Singapore Digital Broadcast Comments by Sony Corp

Date	Version	Release By	Comments
5 th Jan '12	1.0	M Fakhruddin	Initial release
6 th Aug `12	2.0	Lee Shook Yee	Response to the Draft Technical Spec for T2 Receiver (IDA-MDA TS IRD-T2) 1 Aug 12
8 th Aug '12	2.1	Lee Shook Yee	Revised comments and added Section 4.2 for Channel Zapping Time

5.1 Required output from AFD

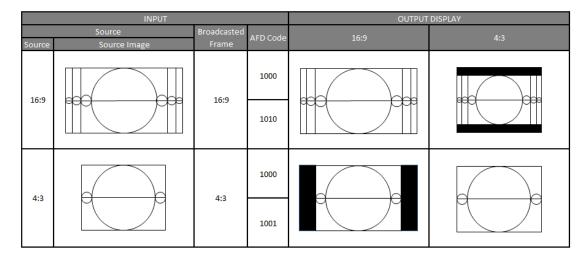
Table B.6 of ETSI TS 101 154 defines AFD format in its coded frame. It does not specify the required receiver's output.

We suggest that the Singapore specification includes illustration of the required output on 4:3 and 16:9 displays. (We have prepared an illustration of the required outputs based on the AFD values specified in the specification. Please see Section 5.1)

Illustration of the required outputs based on the AFD values specified in the Singapore Receiver Specification.
